Proposed Student Accommodation EAST STREET, READING Design & Access Statement ADDENDUM

Client Studios Development (Reading) Ltd

Job No: **18053**

This addendum document has been created to explain the revised scheme drawings submitted to the council for approval in January 2019, which supersede those submitted in October 2018, to which the original DAS relates. The two DAS should be read together

1.1 Design Review Panel (DRP)

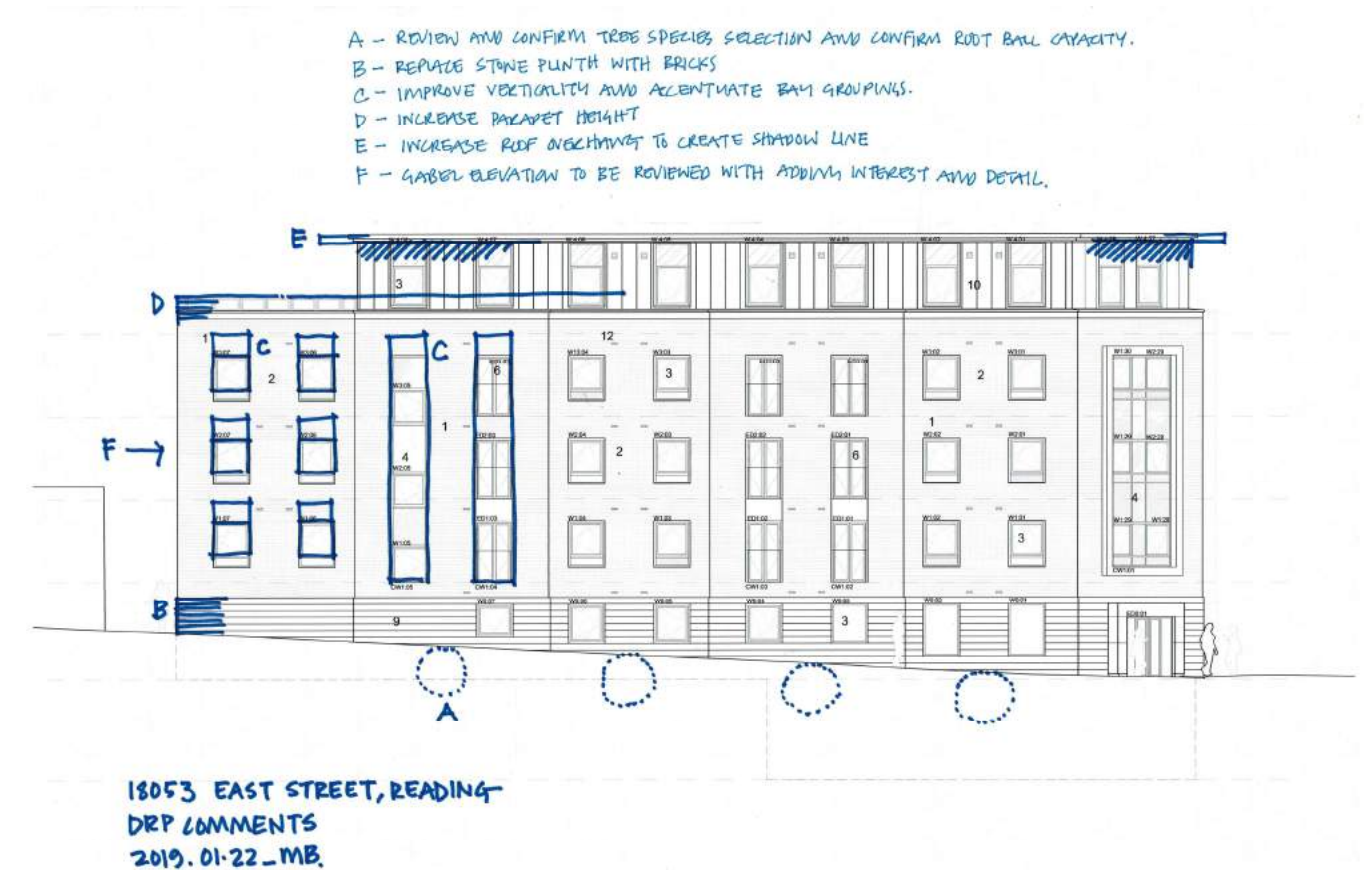
A summary of the comments received are as below;

- Height & Massing – the panel felt that the height and massing of the proposed part 4, part 5 storey scheme was appropriate within its context and sat comfortably within the local townscape

- Top floor – The design team are to review the proportions of the top floor against the overall massing of the building. Possibly increase the parapet so the top floor appears to be less dominant. Remove external handrails

- Stone base – the panel felt that the proportions of the stone plinth didn't work, and recommended the scheme be completely brick, to give a more contemporary feel

- South Gable – gable was seen to be too dominant whilst viewing down East Street. It was suggested that the design team review the elevation to see if any articulation can be incorporated – windows, textured brick etc...

- Heritage – the panel have no issue with the relationship between the proposed building and the rear of the Listed Buildings
- Roof – it was suggested that the roof overhang should be increased to create a shadow line between roof edge and set back top floor

- Verticality – improve verticality and accentuate the window groupings
- Chamfer – the panel discussed the chamfer and agreed that this would add interest to the building when viewing through from Queens Road

- Roof form – the panel were in support of the flat roof
- Materials – the choice of brick as the primary material was accepted as the most appropriate choice for the site and also acknowledged that the metal standing seam cladding helped reduce the impact of the top floor

- Step and set back – stepping the elevation to respond to the surrounding context was seen as a positive feature along with the top floor set back.

Proposed Scheme

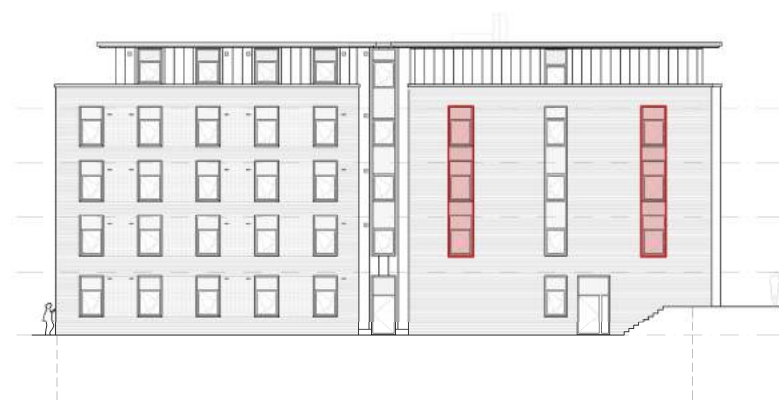
1. **Plinth** – Replace the stone plinth with brick
2. **Roof overhang** – Increase the roof overhang to create a shadow line to the top floor
3. **Parapet height** – Increase the height of the parapet to reduce the scale of the top floor and aid the removal of the external handrails
4. **Verticality** – Accentuate the window groupings and increase the verticality of the fenestration pattern
5. **Southern gable** – Windows introduced along with textured brick panels to the gable to reduce the dominant brick elevation and to add interest and articulation
